# Service Manual

## SE-VC1180

- Notes:**
- This service manual is provided to indicate the main differences between the original model No. SE-CA1080 (E) and the subsequent model No. SE-VC1180 (E, EB, EG).
  - Refer to the Connections, Quick reference of remote control operation and Preparing of the remote control of Service manual for Model No. SL-VC1180 (E), Order No. AD9506160C2.

CHANGES

## A OPERATION CIRCUIT

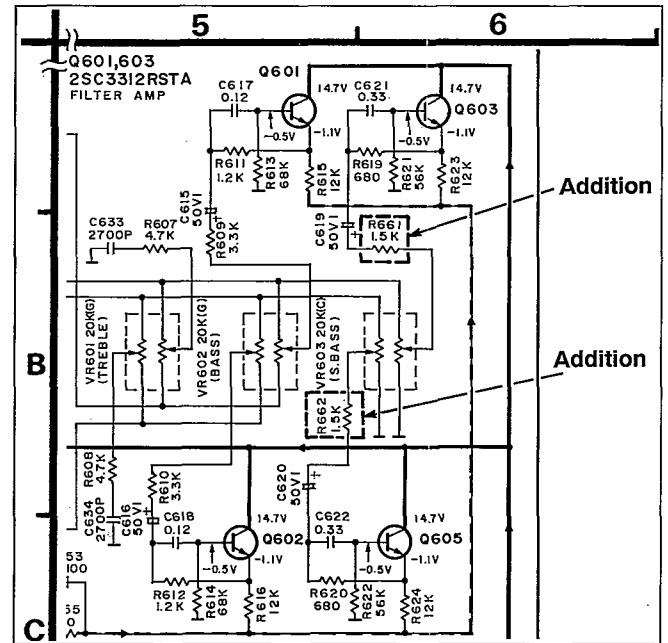
Note: Those parts have added.

SE-CA1080

SE-VC1180

## A OPERATION P.C.B. (REP1924B-S)

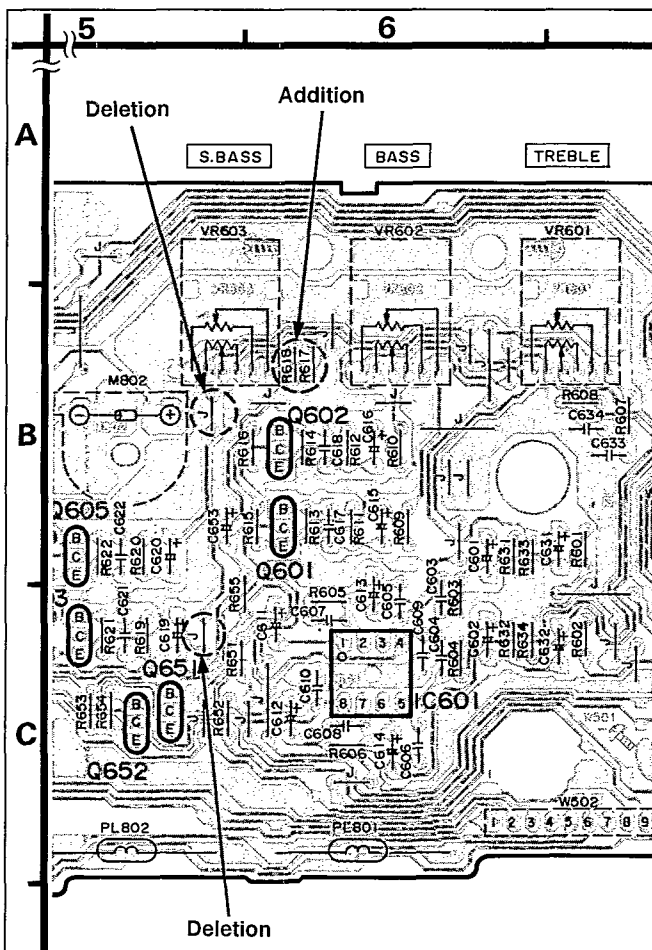
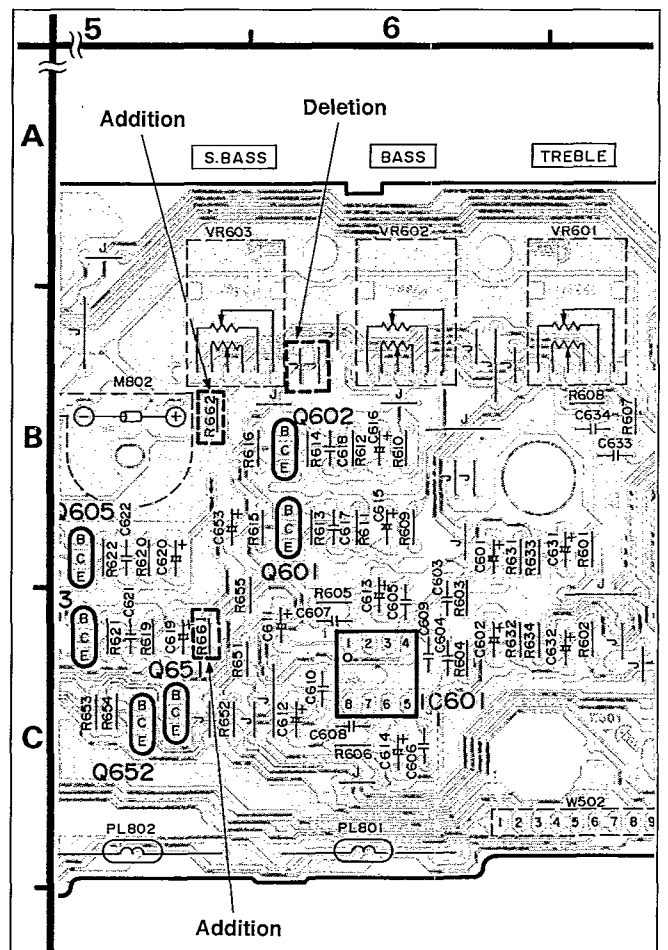
Note: Those parts have added.

SE-CA1080

SE-VC1180

**CABINET PARTS LOCATION** (SE-CA1080 Service Manual of page 16.)

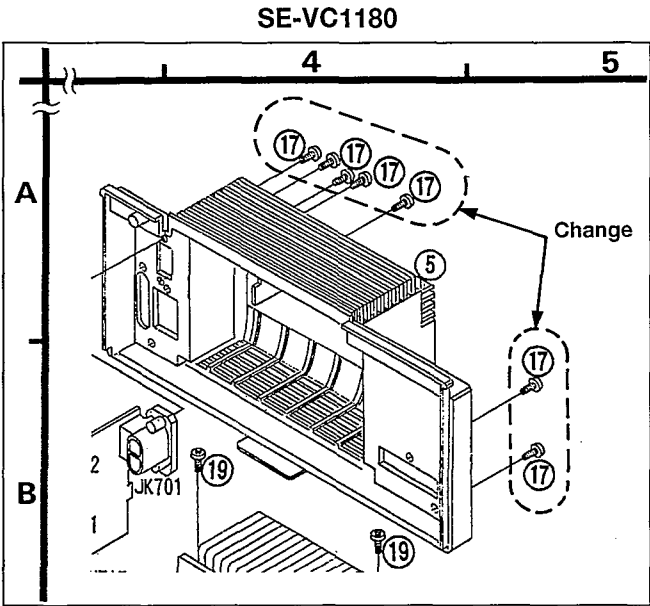
Note: Those parts have changed.

**PACKAGING** (SE-CA1080 Service Manual of page 21.)

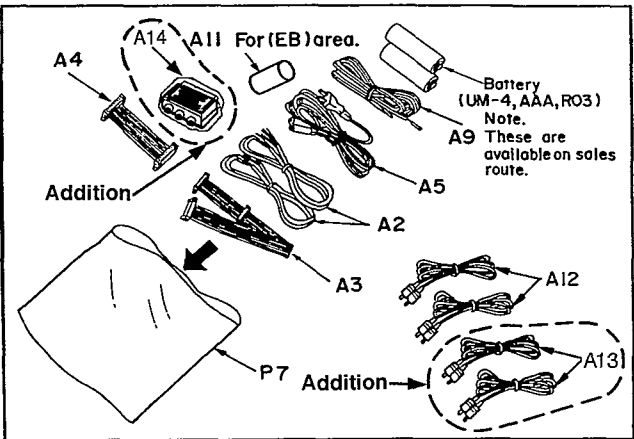
Note: Those parts have added.

## A OPERATION CIRCUIT

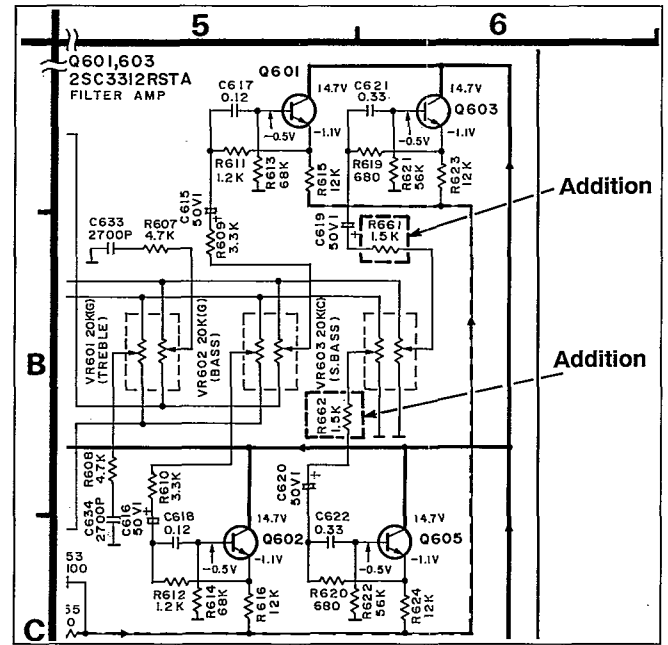
Note: Those parts have added.

SE-CA1080

SE-VC1180

## A OPERATION P.C.B. (REP1924B-S)

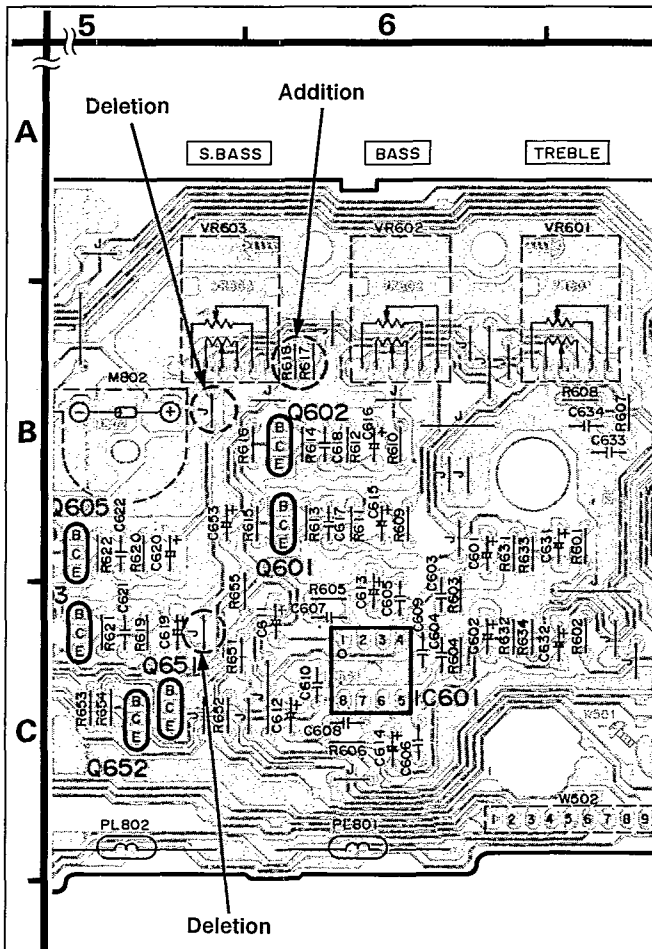
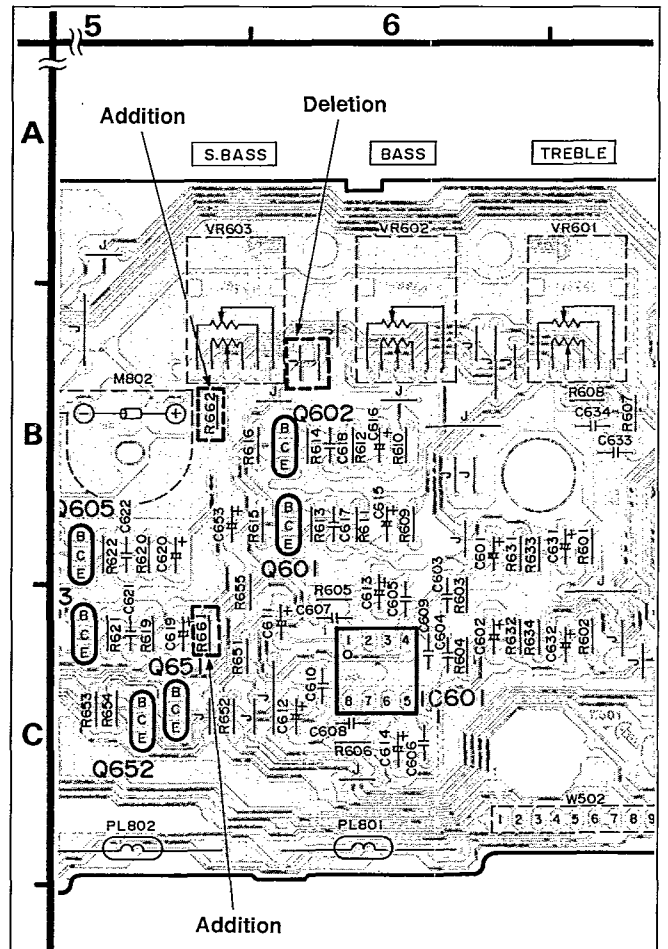
Note: Those parts have added.

SE-CA1080

SE-VC1180
